To <planningcommission@co.slo.ca.us>
cc
bcc
Subject GHG Response

Subject: **Green House Gas (GHG)**

Subject: **Oreco Response to Mr. Dubbink's Correspondence**

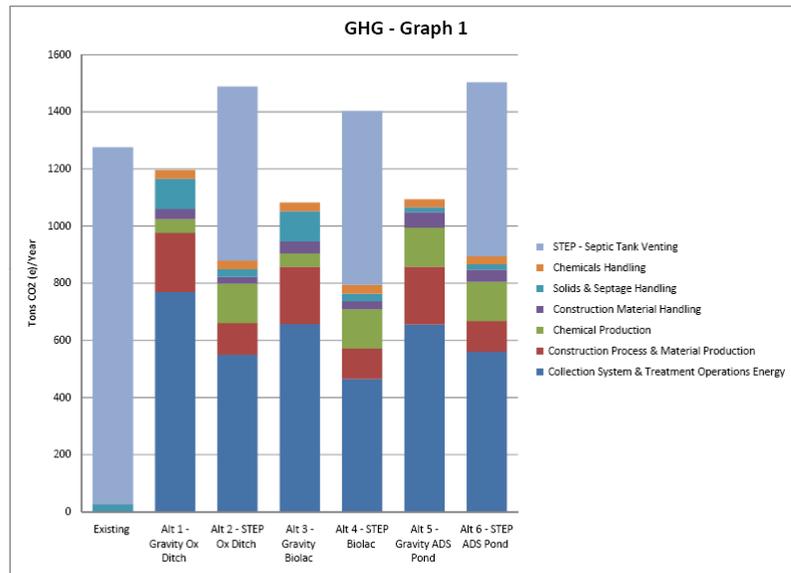
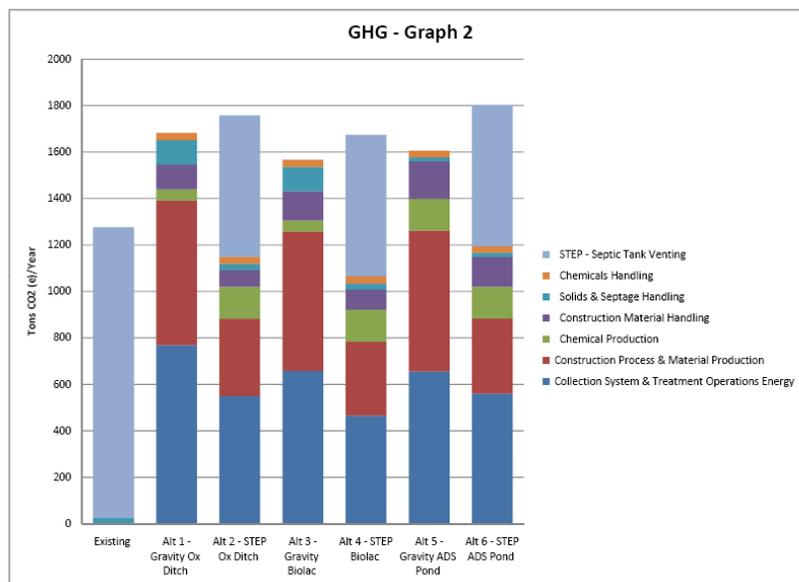
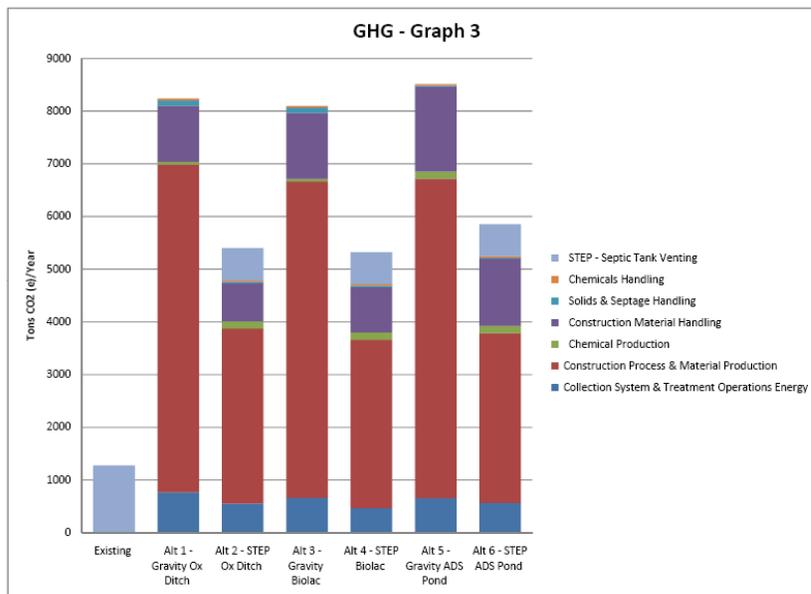
Graph 1, produced by Orenco Systems and shown below, includes GHG emissions associated with construction and annualizes them over 30 years. As you can see, annualizing this impact has made the two applicable impacts (construction material handling, construction & material production) appear to be marginally significant in the overall accumulation of GHG emissions. By this apparent manipulation of data, the benefits of STEP collection construction and material handling are hidden from the reader by making gravity sewer construction and material handling less significant in the annual emissions. Again remember, the GHG emissions for construction have been divided by 30 which makes gravity sewer annual emissions smaller relative to the other impacts.

If we simply change the annualization period for the construction impacts to 10 years, the outcome of the analysis changes significantly. Graph 2, shown below was developed by changing the annualization period from 30 years to 10 years. At 10 years, the gravity sewer options have changed significantly and the construction related GHG emissions are a dominant impact to the outcome of the analysis. We're not speculating that 10 years is an appropriate annualization period, we're simply trying to show how a subtle change in the approach can change the outcome significantly.

To further demonstrate this issue, we could restate the GHG impact of construction related activities without annualizing the data. Graph 3 shows the GHG emissions for construction related activities as an initial impact. Without annualizing the construction related impacts, the construction related GHG emissions are the dominant factor that affects the outcome of the GHG analysis. At the very least, it becomes very obvious that the construction related GHG emissions should not be ignored in the overall discussion. In rough numbers, the construction related GHG emissions are equal to approximately 7 years of operations GHG emissions.

We believe that construction related GHG emissions should be detailed and evaluated separate from operational GHG emissions. Again, in rough numbers, any alternative inclusive of STEP collection would have approximately 1/2 the construction GHG emissions when compared to gravity sewer based options. If GHG construction emissions of STEP collection was compared directly with gravity collection (no treatment), we believe STEP would be much lower than 1/2 of the of gravity.

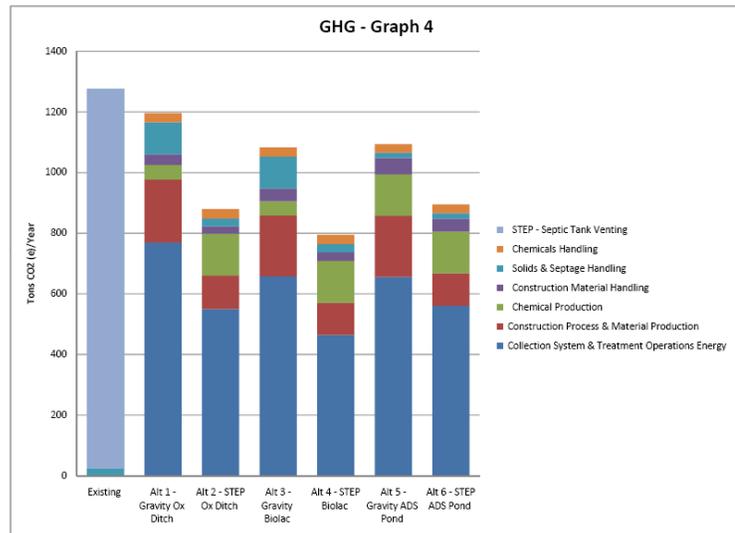
Our comments on the technical memorandum questioned the magnitude of the STEP tank methane being produced. We questioned the inconsistency between the construction impacts and the methane STEP tank emissions. While construction impacts were averaged over 30 years, septic tank emissions were derived from day one, assuming non existing tanks that would materialize upon full build out. A real and immediate impact in the gravity sewer column was averaged, while a nonexistent impact from nonexistent STEP tanks was utilized in day one of the analysis.

We also questioned the science behind methane production as ground temperatures in the Los Osos region do not support methane production. Furthermore, more frequent pump-out intervals can also be utilized should methane production occur. It is critical to note that the accuracy of GHG emissions must be verifiable. We do not believe that the quantity of methane gas from vented STEP tanks is accurate nor is it verifiable.

Figure 1: Orenco diagrams (right) superimposed on Los Osos base map.

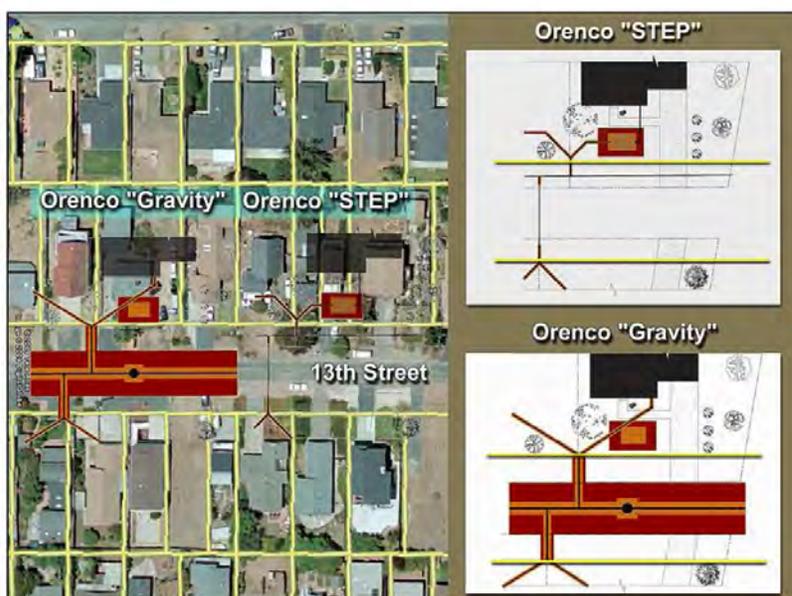
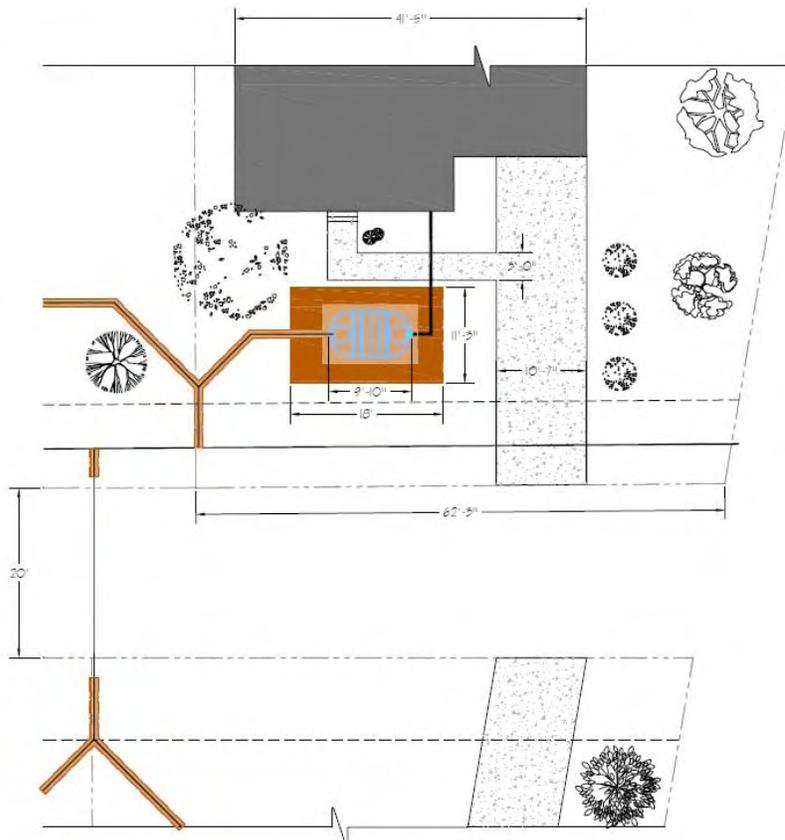
Statement #3 : There are obvious problems. The houses (shown in darker grey) and their yards are quite large compared to what actually exists in Los Osos. The setback of the houses from the

street is 44 feet where the community setback standard is 25 feet. The width of the parcels shown on the Orenco scale to a lot width of 134 feet. (The measurements were made using the scaling features of Google Earth)

Mr. Dubbink's attempt to scale the Orenco comparison of impact to the Los Osos Google map is inaccurate. Orenco's drawing is shown below with dimensions added. The front of the lot is 62'3" wide and not 134' as Mr. Dubbink has asserted. Again, the intent of the drawing was to show a "whole view" comparison and not just an on-site only comparison. It is also intended to show that excavation limits have a range depending on the soil type and shoring utilized. Mr. Dubbink has been promoting gravity sewer calculations that show a 3' wide trench that could be cut more than 20'. This trench width is inconceivable from both a logistical and construction safety perspective.

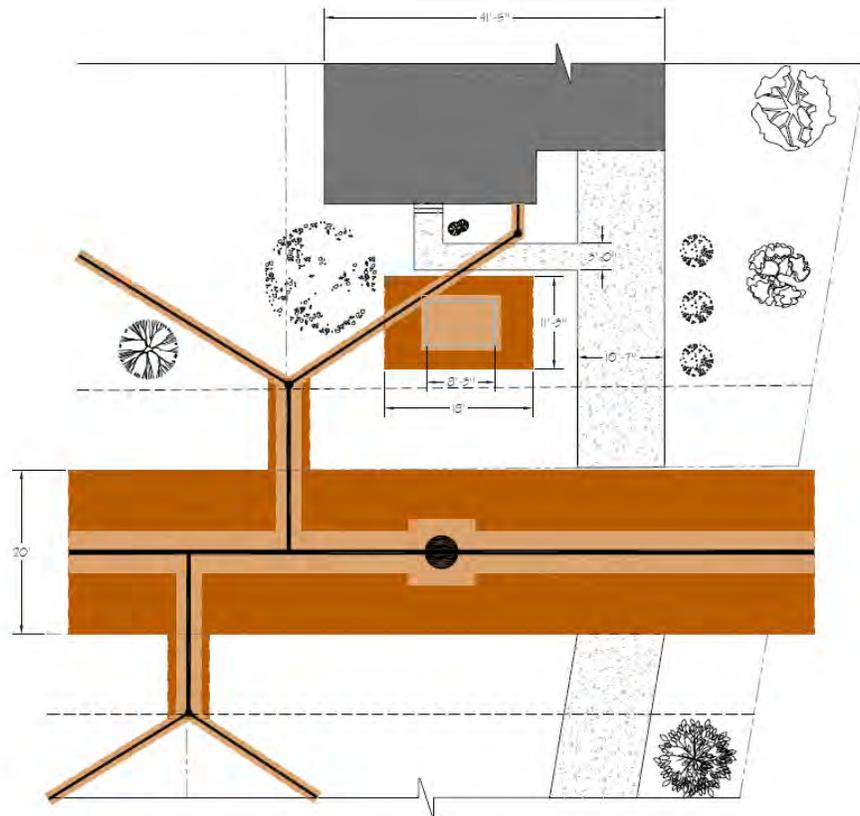
Statement #4 - The impact of the excavation for a gravity trench in the Orenco diagram is alarming. In the “best case” the width of the pipeline trench is 11 feet and in the “worst case” the trench is 43 feet across. Luckily, Orenco’s depiction has no resemblance to actual plans. And it is not only the trenching that is amiss. The plans for the gravity system aligned the laterals perpendicular to the street where Orenco shows them at 45 degree angles.

Since Mr. Dubbink has more than doubled the scale of the Orenco drawing, there really isn't much credibility to this statement. The dimensioned gravity sewer drawing is shown below. In actuality we're showing the maximum limit of excavation as 20' at the surface. In reality, the excavation limit could be much more. In order to provide shoring, access for pipe assembly, dewatering, and to satisfy OSHA trench excavation requirements, a 20' deep gravity sewer excavation can easily be 20' across at the surface.

Figure 2: Alternate representation based on setback

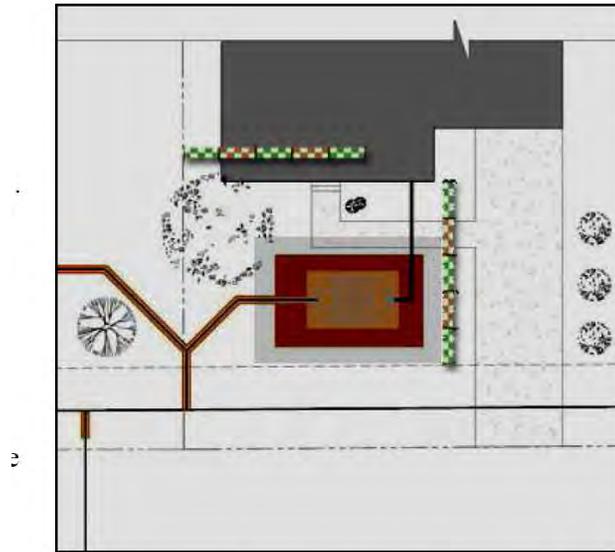
Statement #5: While changing the scale shrinks the size of the houses, the size of the excavation shrinks too. In the “best case” the tank excavation scales to 8 by 13 feet. The Orenco 1,500 gallon tank measures 7 x 15 feet in its outer dimensions and it wouldn’t fit into such an excavation. The “worst case” excavation size is 12 by 20 feet. Orenco’s tank installation manual calls for side clearances of 2 feet on all sides. The tank would barely fit if the excavation were straight-sided. If a more realistic 2:1 side slope is assumed, the excavation would be 17 x 25 feet. This substantially larger than what is shown in the Orenco diagram. The grey tone on Figure 2 shows the outline of an excavation of this size.

Orencia fiberglass tanks **WERE NOT** proposed for use in the Los Osos project. Alternatively, concrete tanks were proposed. The length and width dimensions for a 1500 gallon tank (6'W x 11'L x 6.25'D) would actually represent a very large 1500 gallon concrete tank with an H20 traffic rated lid. In practicality the size of concrete septic tanks are highly variable due to wall thickness and the amount of freeboard (room above the 1500 gallon level). I have found concrete 1500 gallon tanks as small as 5.5'W x 9.5'L x 5'D. Therefore the size of the concrete tank was conservatively stated on the larger side. When an excavation is made to remove and replace the existing concrete tank, shoring can be provided with steel shoring to limit the excavation size. The maximum limits in the drawing are scaled to be 11'3" by 18'. This is more than reasonable.

Figure 4: Native oaks in Los Osos front yards

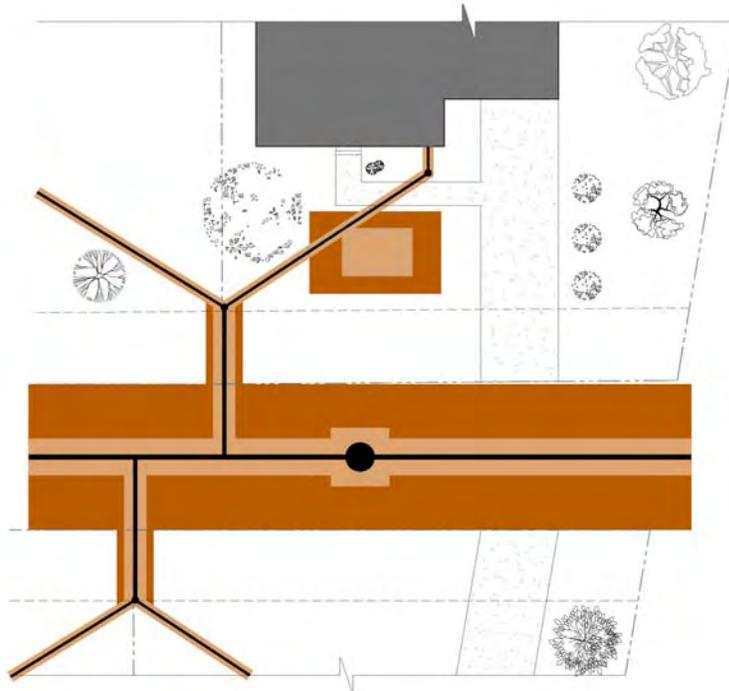
The site disturbance problem is not just about “grass and gladiolas” as it has been derisively dismissed by some. Figure 4 shows photos of two houses not far from mine. Both have stands of native oaks in the front yard and both pose significant problems in siting a STEP tank. Compounding this, the 10th Street house is at the center of a mapped archeological site (SLO-458). The choice in such situations is between removing trees and potentially disturbing cultural resources or removing the driveways which necessitates reinforcement of the a standard fiberglass STEP tank (what happens with the tank’s twin turrets is unknown). It is evident that additional homeowner costs are involved. This illustrates the accuracy of the proposition that some of the savings for STEP installation are offset by increased costs to property owners. It also is evidence supporting the EIR’s conclusion that the STEP alternative has the greater impact on environmental resources.
